**PARTS & SERVICE
NEWS**

REF NO.	AT00119
DATE	Jul. 11, 2000

SUBJECT: REPAIR OF WEAR-PRONE FUEL INJECTION PUMP AIR BLEEDING PIPING CLAMP SECTION ON HD785-3, 5, HD985-3, 5

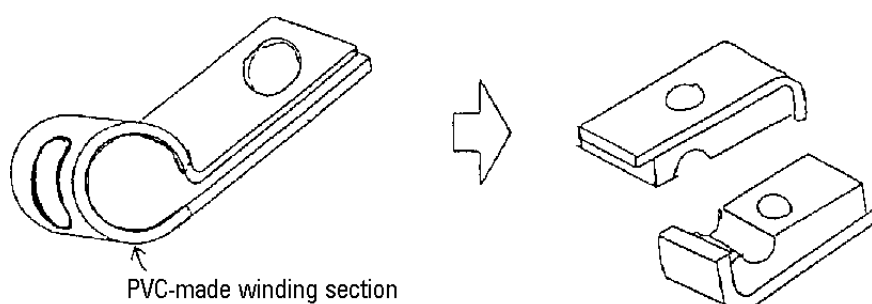
Regarding the captioned matter, by rubbing between the air bleeding piping for the fuel circuit and its clamp being caused by vibrations of the engine, the air bleeding piping may wear to create holes in its clamped section resulting in fuel leakage.

To prevent occurrence of the aforementioned fuel leakage failure, make the modification being introduced in this Service News.

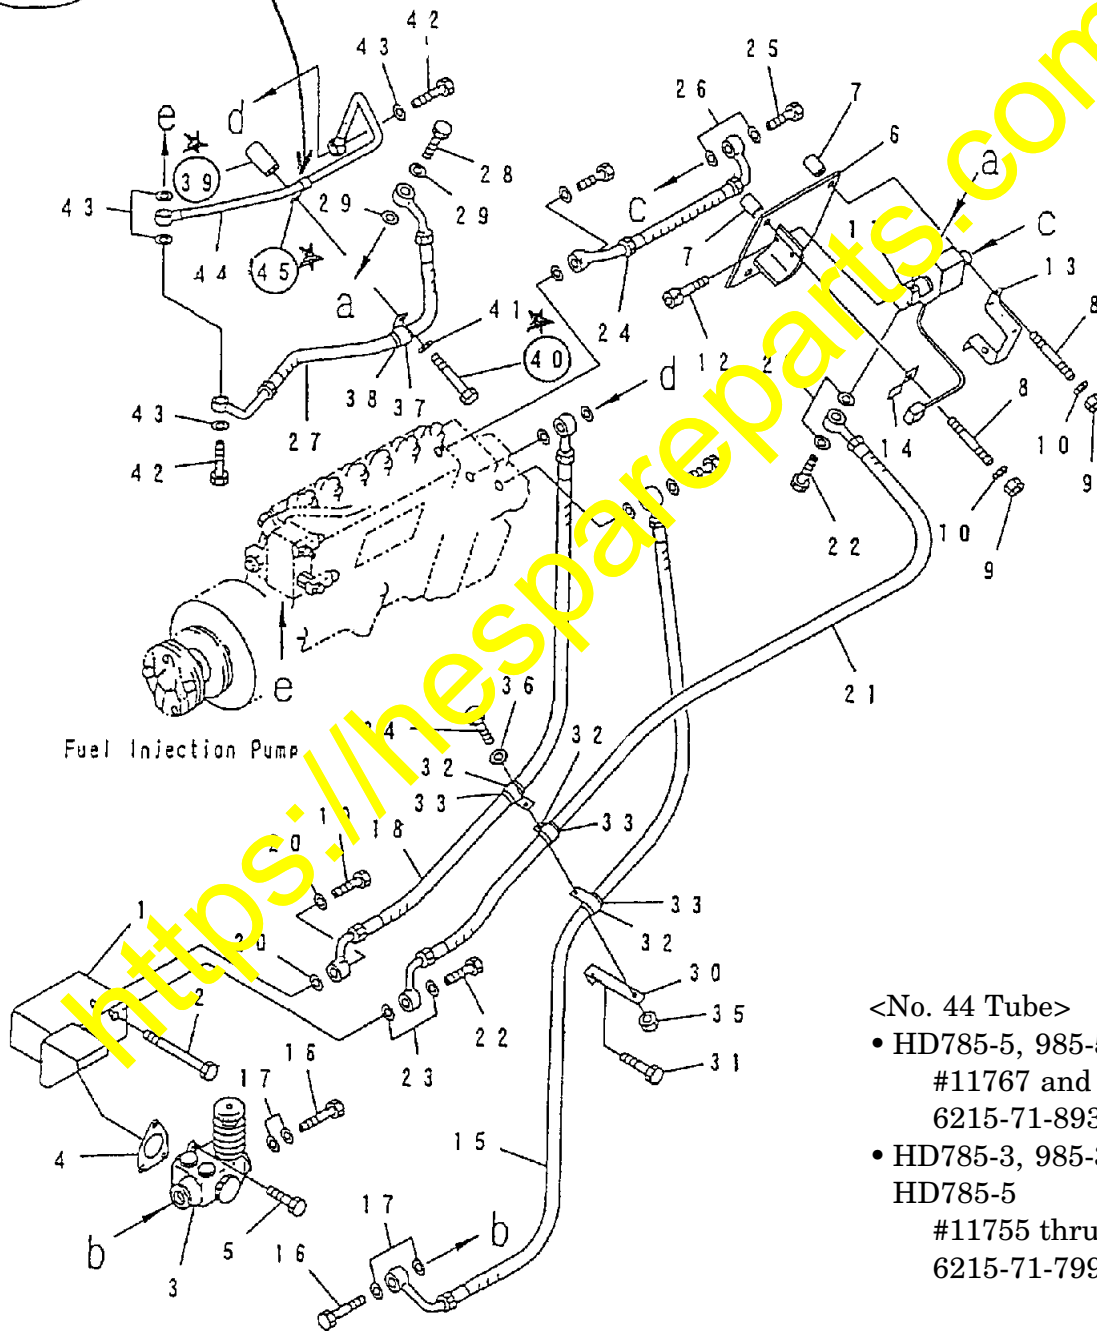
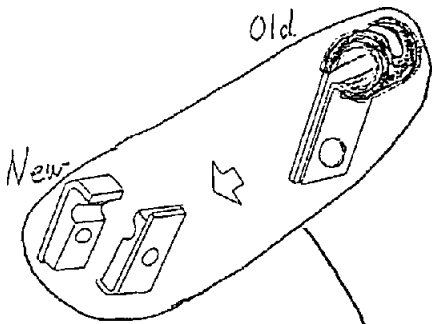
Change the clamps from the winding-type clamps (04434-XXXXX) to molded clamps.

Bolts No. 40
Spacers No. 39
Clamps No. 45
and chassis side parts

Drwg. No.	NEW			OLD		
	Part No.	Part Name	Q'ty	Part No.	Part Name	Q'ty
45	6215-71-6931	Clamp	1	04434-51008	Clip	1
	6215-71-6941	Clamp	1			
40	01010-80860	Bolt	1	01010-80850	Bolt	1
39	6167-11-8220	Spacer	1	6144-11-5630	Spacer	1

Fuel piping (L.H. bank) (For electrical governor) #11755 and up

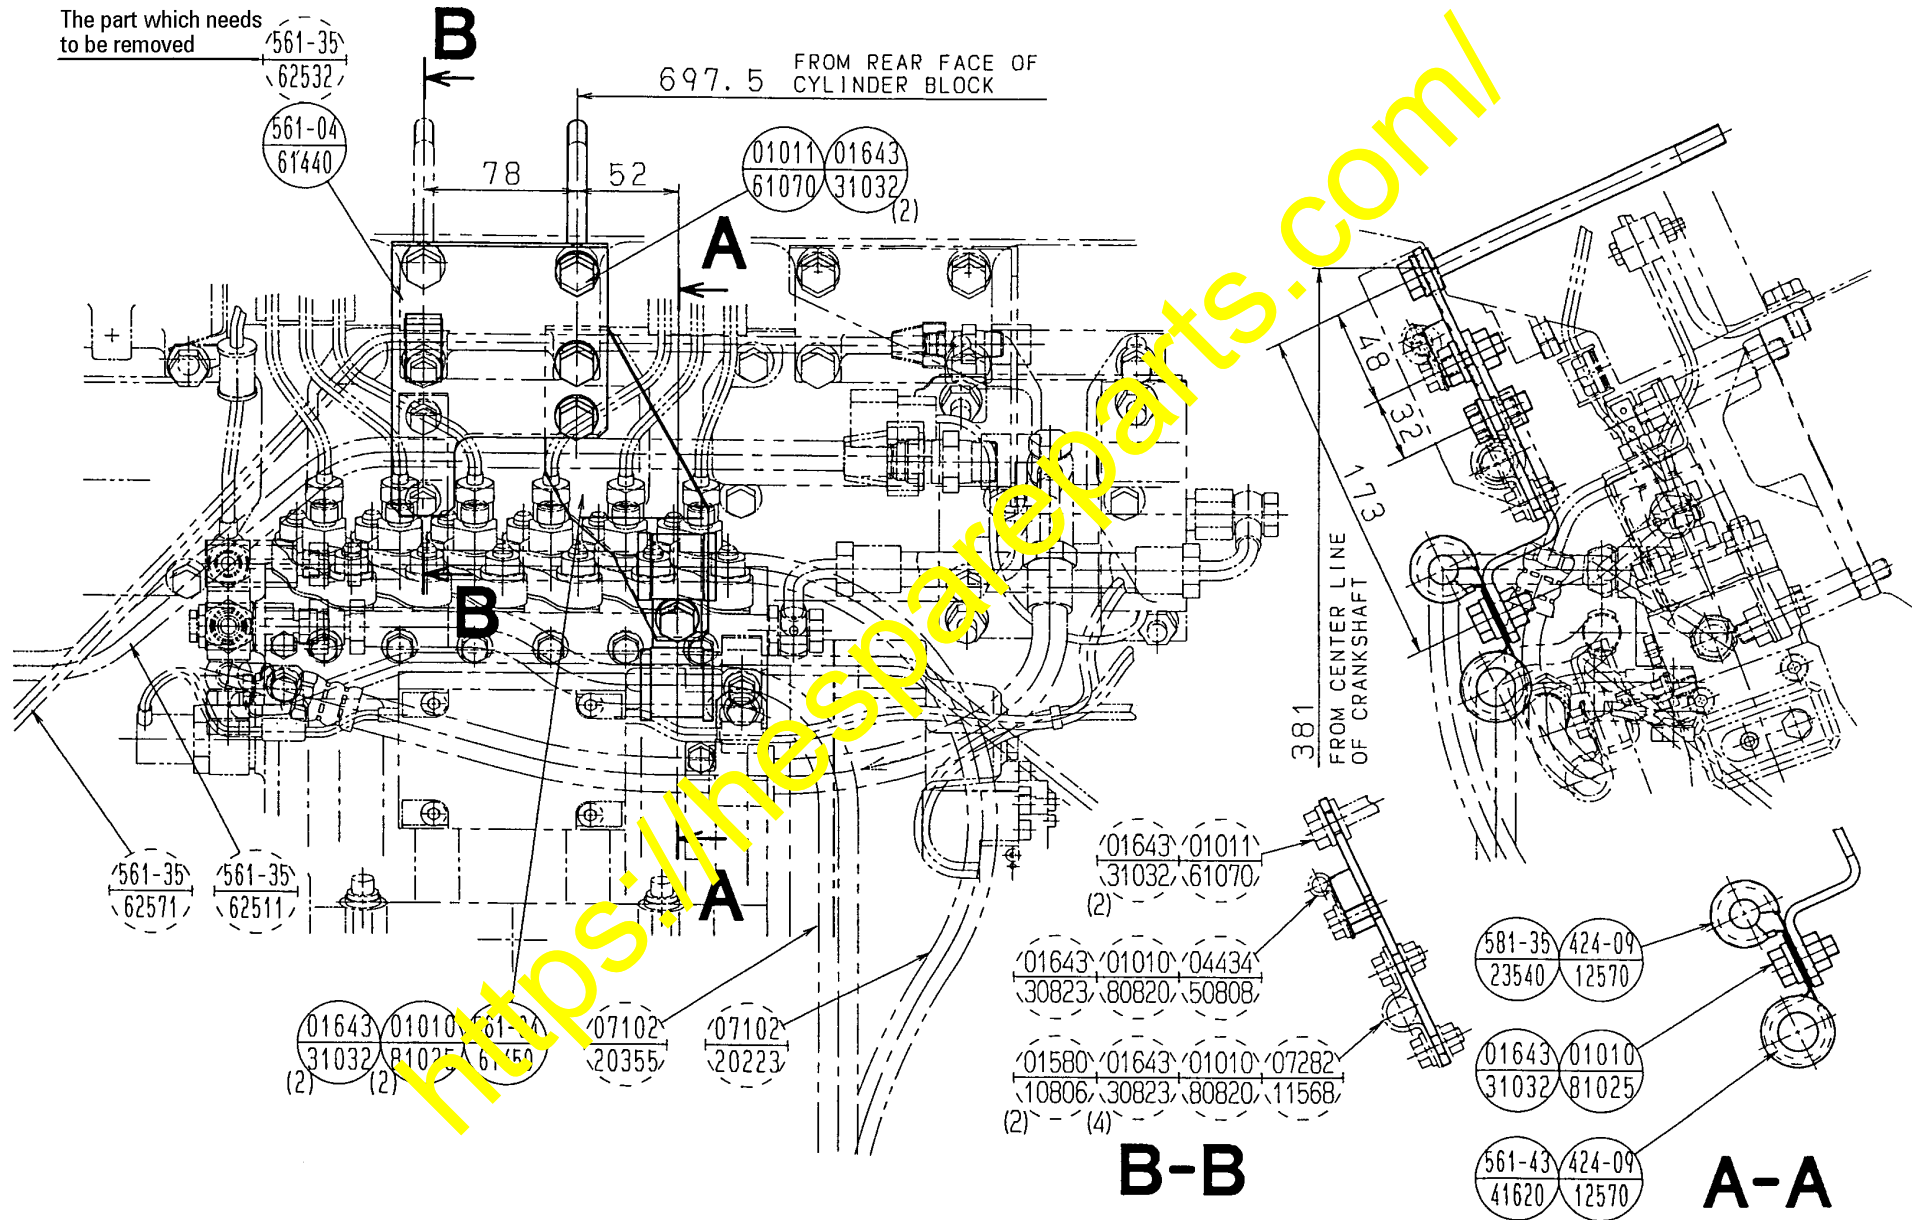
- <No. 44 Tube>
- HD785-5, 985-5:
#11767 and up
6215-71-8930
 - HD785-3, 985-3:
HD785-5
#11755 thru 11766:
6215-71-7990
